ENGINEER'S SUPPLEMENTAL INSTRUCTIONS NO. THIRTY (30)
(Via Posting to FTP Site and Electronic Mail)

RE: Harold D. Thompson Regional Water Reclamation Facility (HDTRWRF)-Phase 1
ENGINEER'S SUPPLEMENTAL INSTRUCTIONS THIRTY (ESI-030)

3 FILTRATE PUMP CRANE PLAN

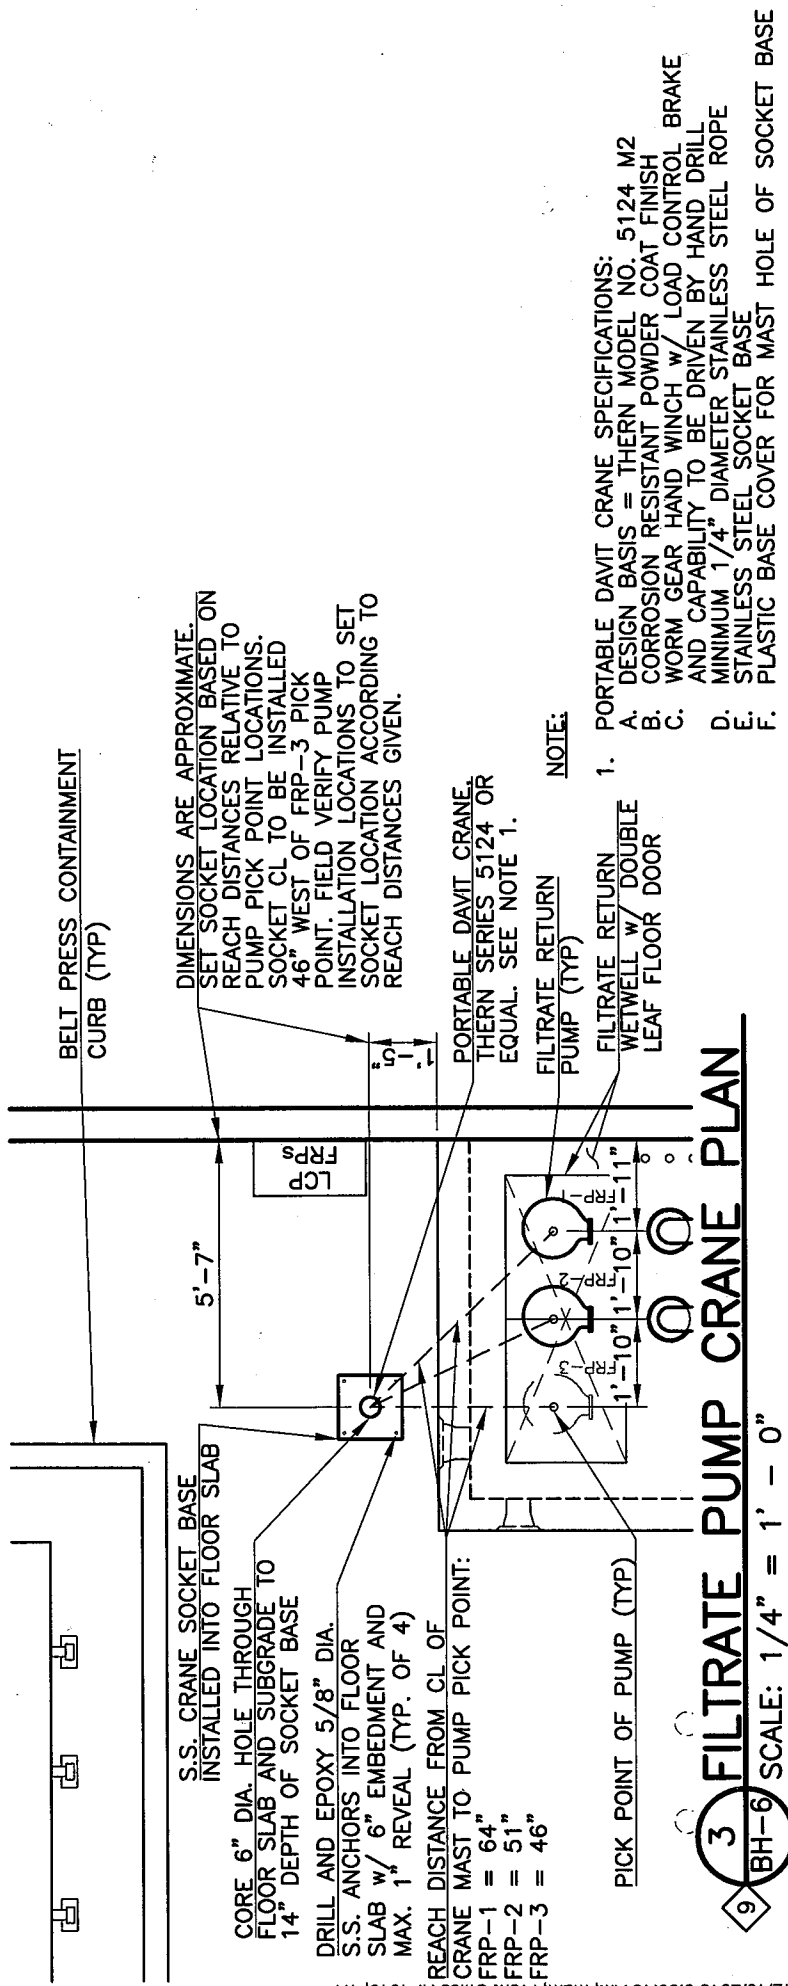
This ESI-030 provides information on additional work required in the Biosolids Handling Complex to facilitate removal of the filtrate return pumps. This work involves the provision of a portable davit crane and the installation of its socket base in the building floor slab. The drawing attached to this ESI-030 provides the installation details and requirements related to this work. It should be noted that the installation location of the socket base for the davit crane shall be set relative to the as-constructed locations of the filtrate return pumps. Refer to the attached Detail 3/BH-6 for the specific details required for the placement of the crane's socket base.

DIMENSIONS ARE APPROXIMATE. SET SOCKET LOCATION BASED ON REACH DISTANCES RELATIVE TO PUMP PICK POINT LOCATIONS. SOCKET CL TO BE INSTALLED 46" WEST OF FRP-3 PICK POINT. FIELD VERIFY PUMP INSTALLATION LOCATIONS TO SET SOCKET LOCATION ACCORDING TO REACH DISTANCES GIVEN.

CORE 6" DIA. HOLE THROUGH FLOOR SLAB AND SUBGRADE TO 14" DEPTH OF SOCKET BASE

DRILL AND EPOXY 5/8" DIA. S.S. ANCHORS INTO FLOOR SLAB w/ 6" EMBEDMENT AND MAX. 1" REVEAL (TYP. OF 4)

REACH DISTANCE FROM CL OF CRANE MAST TO PUMP PICK POINT:
 FRP-1 = 64"
 FRP-2 = 51"
 FRP-3 = 46"

1. PORTABLE DAVIT CRANE SPECIFICATIONS:
 - A. DESIGN BASIS = THERN MODEL NO. 5124 M2
 - B. CORROSION RESISTANT POWDER COAT FINISH
 - C. WORM GEAR HAND WINCH w/ LOAD CONTROL BRAKE AND CAPABILITY TO BE DRIVEN BY HAND DRILL
 - D. MINIMUM 1/4" DIAMETER STAINLESS STEEL ROPE
 - E. STAINLESS STEEL SOCKET BASE
 - F. PLASTIC BASE COVER FOR MAST HOLE OF SOCKET BASE
